# Memo

**To:** The Atherton Planning Commission  
**From:** Sally D Bentz, Town Arborist  
**CC:** Brittany Bendix, Consulting Town Planner  
**Date:** March 26th, 2025  
**Re:** Heritage Tree Removal Application and TPZ exception at 53 Euclid

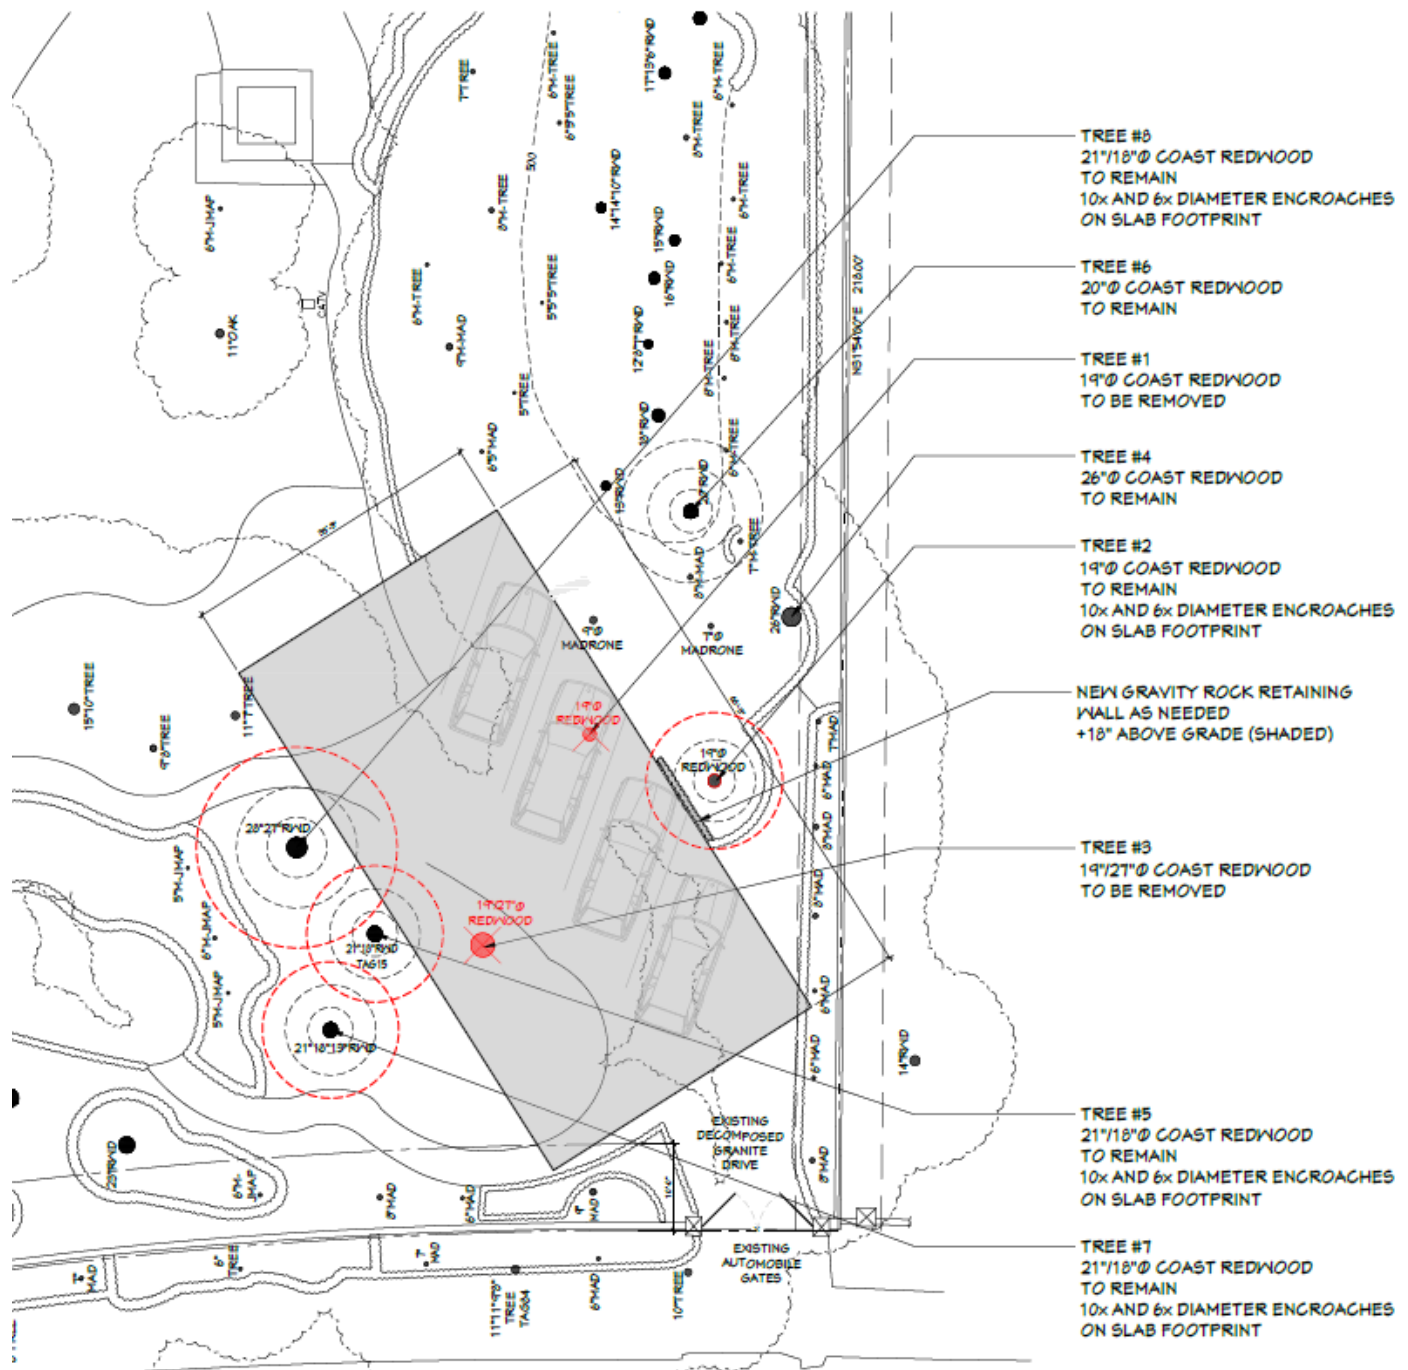
I received an update site plan on 3/6/25. Please see the following. The applicant requests the below:

- TREE 1 – 19" Redwood – requesting removal
- TREE 2 – 19" Redwood – proposing to preserve. TPZ exception 3x
- TREE 3 – 19/27" Redwood. – I can approve at staff level
- TREE 4 – 26" Redwood – proposing to preserve. TPZ exception 3x
- TREE 5 – 21" Redwood – proposing to preserve. TPZ exception 5.5x

The applicant is now applying for one less tree removal. They are proposing to remove tree #1. Tree #3 is a tree I can approve at staff level because it is dangerous.

There is one owner for both 37 and 53 Euclid. There is a driveway and garage at 37 Euclid. It was stated the proposed parking space is for staff. I don't feel I can approve of the one healthy redwood and the TPZ exceptions for staff parking. Staff parking is not a requirement, and the public can park in the right way.

Tree removal request – Tree #1 -Redwood 19” –I can approve the removal based on the below:

- Explored 3 locations. This is only the location for the pad.
- The applicant has worked to find the best location with the least amount of impact to heritage trees on site.
- The three trees for a TPZ exception can be granted as the pad is on grade and arborist will be site during construction. Minor impact on roots. No roots over 2” are proposed to be cut. The retaining wall that is proposed is because tree #2 is in a raised planter and because you do not want to change the grade the wall is the best option.

If the Planning Commission approves the removal of tree #1, then the below exceptions must be approved by the Planning Commission. Per town code a new driveway must be 8x away from any heritage trees. This new pad would need to meet the TPZ zone requirements for a new driveway. If they want new portions of the parking pad to comply with TPZ then anything under 8x would require the Planning Commission approval of lower TPZ zones.

- TREE 2 – 19” Redwood – proposing to preserve. 3x
- TREE 4 – 26” Redwood – proposing to preserve. 3x
- TREE 5 – 21” Redwood – proposing to preserve. 5.5x

- Arborist to be on site when pad is being installed
- Report to be submitted by arborist about root cutting, photos and dates the arborist was on site
- Required to only hand dig the pad 8x away from any heritage tree(s)
- No grading in 8x TPZ zone
- Deep water the trees 2x a month for 6 months. Provide proof 6 months after permit issuance.
- No roots over 2" diameter to be cut.

I do not agree with the applicant I would recommend a 36" box tree planted in the right of way or another location on site within 37 or 53 Euclid.
